ADDENDUM No. 1

PROJECT MANAGEMENT - PUBLIC SERVICES - CITY OF ANN ARBOR  
GEDES AVENUE IMPROVEMENTS  
PROJECT DETAILS  
INFILTRATION DETAILS

PROJECT MANAGEMENT - PUBLIC SERVICES - CITY OF ANN ARBOR  
GEDDES AVENUE IMPROVEMENTS  
GEDDES AVENUE TYPICAL SECTIONS  
P.O.B. TO 23+75

PROJECT MANAGEMENT - PUBLIC SERVICES - CITY OF ANN ARBOR  
GEDES AVENUE IMPROVEMENTS  
STORM SEWER PLAN AND PROFILE  
STA. 37+50 TO STA. 41+50

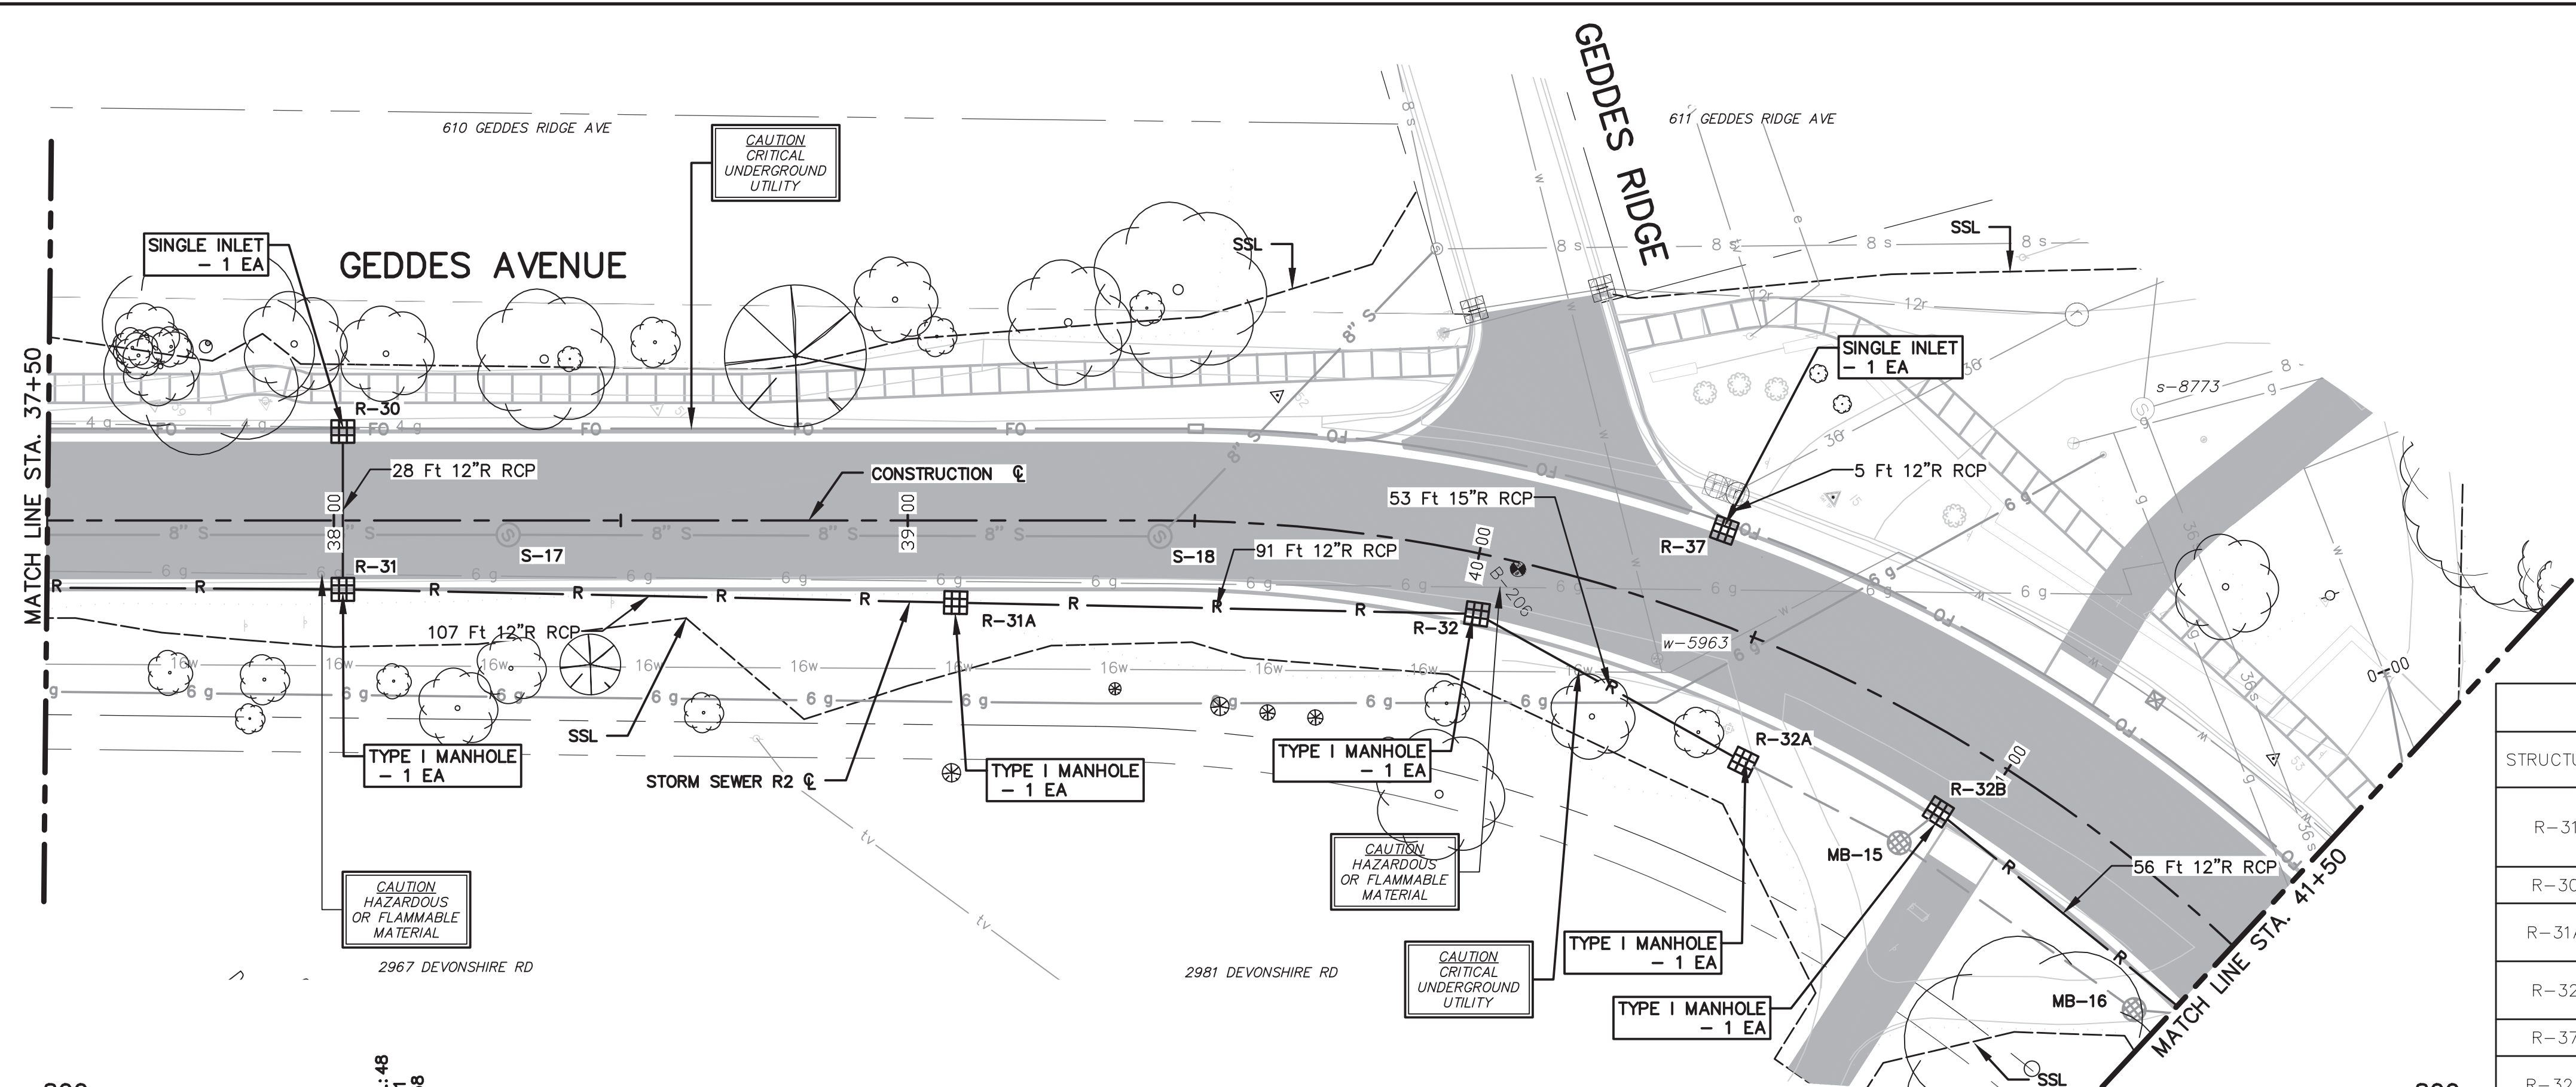
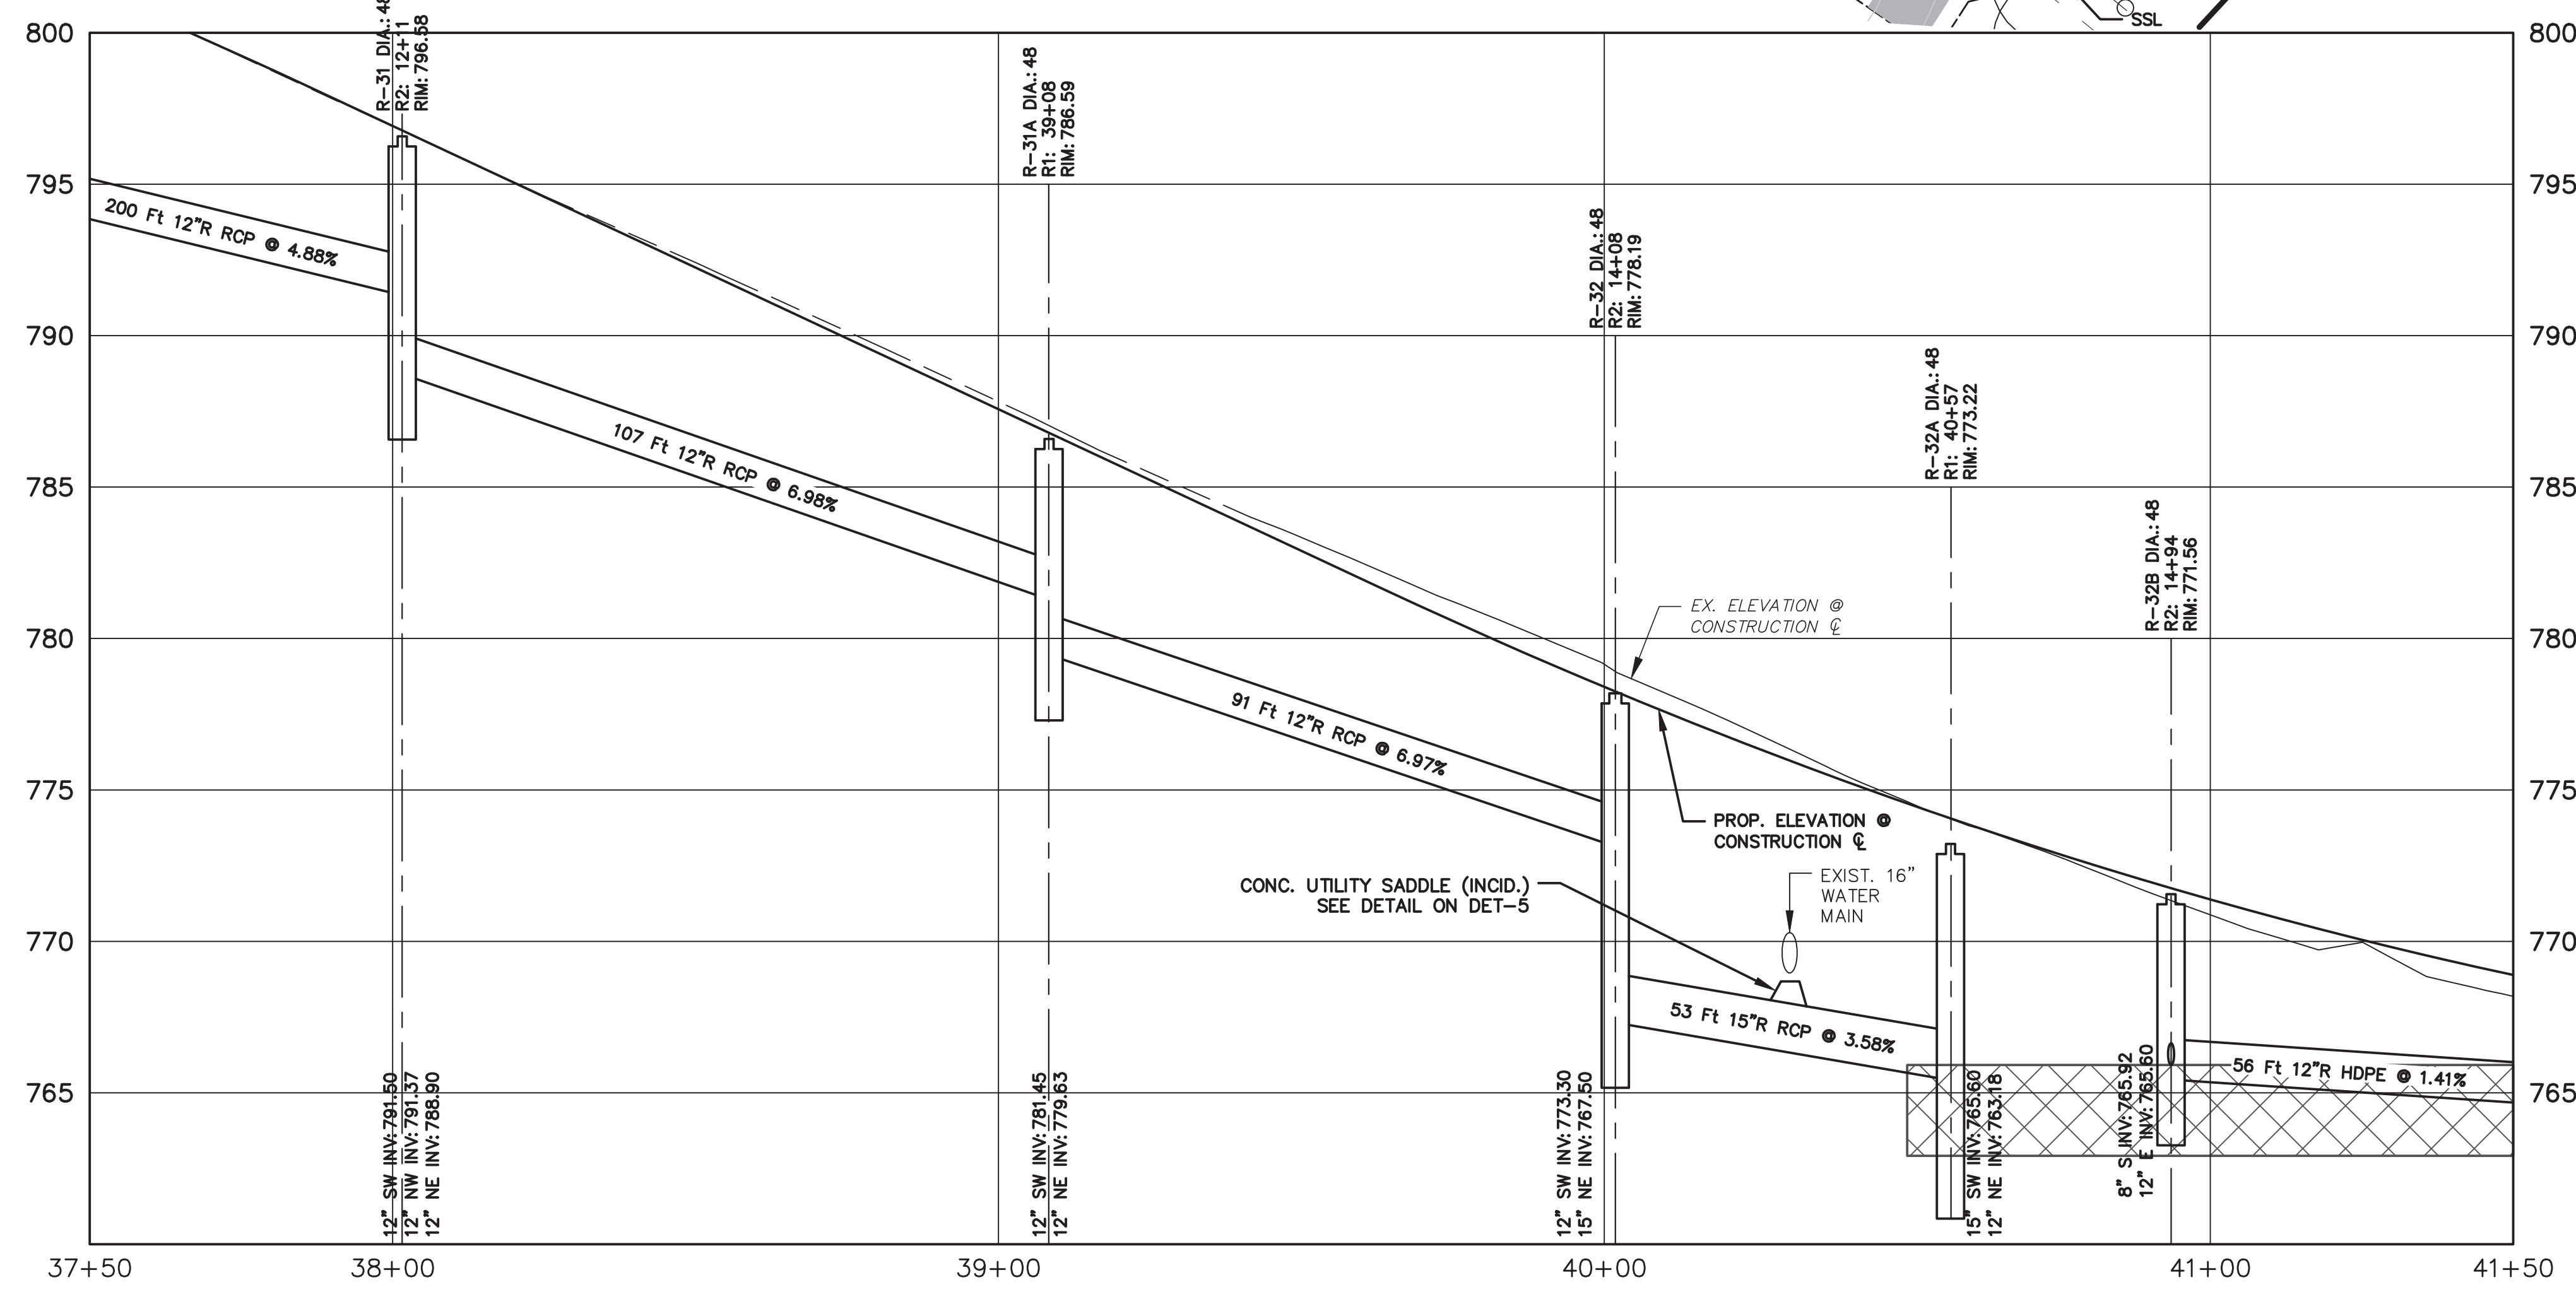
ALL DEPTH INFORMATION HAS BEEN UPDATED IN THE STORM SEWER STRUCTURE TABLE.
